Serial: NPD-NRC-2010-082
November 5, 2010

**SHEARON HARRIS NUCLEAR POWER PLANT, UNITS 2 AND 3
DOCKET NOS. 52-022 AND 52-023
RESPONSE TO ACTIONS FROM OCTOBER 1, 2010 PUBLIC TELECONFERENCE
CONCERNING TRITIUM MODELING**

NRC RAI #: Supplemental RAIs 5.2.2-5, 5.4-1, and 5.4.2-2

PGN RAI ID #: H-0640

FIGURE 1.
Comparison of Observed Tritium Data to Initial and Calibrated Model Results

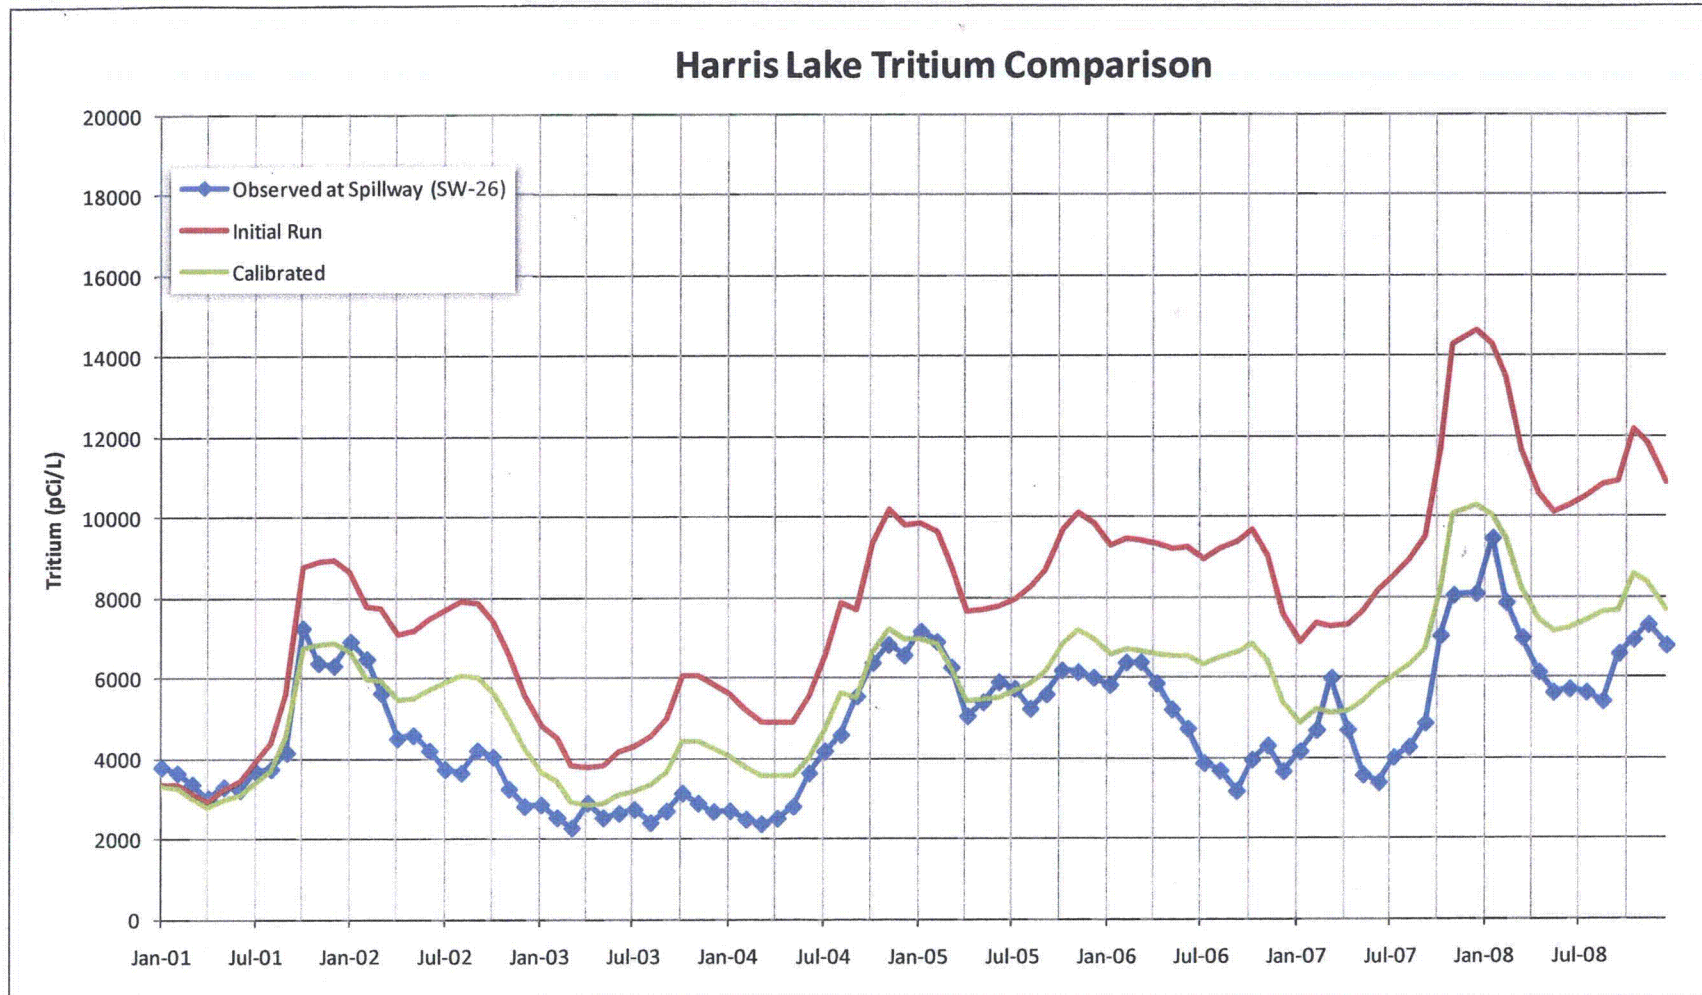
1. Progress Energy Carolinas, Inc. (PEC) will provide a summary of the statistical data used which illustrates the calibration results for the CE-QUAL-W2 model of Harris Reservoir.
2. PEC will provide electronic copies of the output files for the CE-QUAL-W2 model runs of tritium concentration in Harris Reservoir.
3. PEC will provide an explanation of why a 30 percent reduction loading of tritium was necessary to calibrate the CE-QUAL-W2 modeled tritium results with measured tritium concentration in Harris Reservoir.

3. As described in RAI 5.4.2-2 (H-0513), a 30 percent reduction in tritium loading was selected during the model calibration. Monthly tritium concentration measurements are collected in Harris Lake near the Main Dam spillway at Station SW-26. These data were used for calibration of the CE-QUAL-W2 model. The initial calibration run showed consistent replication of trends in tritium concentrations, but overestimated levels by 30 to 50 percent, as shown on Figure 1.

Reductions to the source term were tested to calibrate the model to the observed data. The two droughts in the 2000s were some of the most extreme since drought conditions have been monitored in North Carolina. These are critical periods since inflows are limited but tritium loading continues. While a reduction of approximately 50 percent resulted in the most consistent fit, a reduction of 30 percent was selected since it most closely matched the peak in the observed data during the critical periods. A 30 percent reduction provides a conservative estimate of tritium losses since the predictions are generally higher than the observed. With a few exceptions, the model closely matches or over-estimates the observed data. This result was preferred compared to frequently under-estimating tritium levels. Figure 1 includes a comparison of the simulated tritium with no loss term (red line), the simulated tritium with a 30 percent loss term (green line), and the observed data at SW-26 (blue line).

Since this evaluation is on an average annual basis, an average tritium concentration is required to be assumed over the analysis period. Based on Figure 1, an average concentration between 4000 and 6000 pCi/l can be assumed. The calculated losses for these concentrations are provided in Table 1. This table includes loss estimates for the annual average release for the simulation period, January 2001 through December 2008.
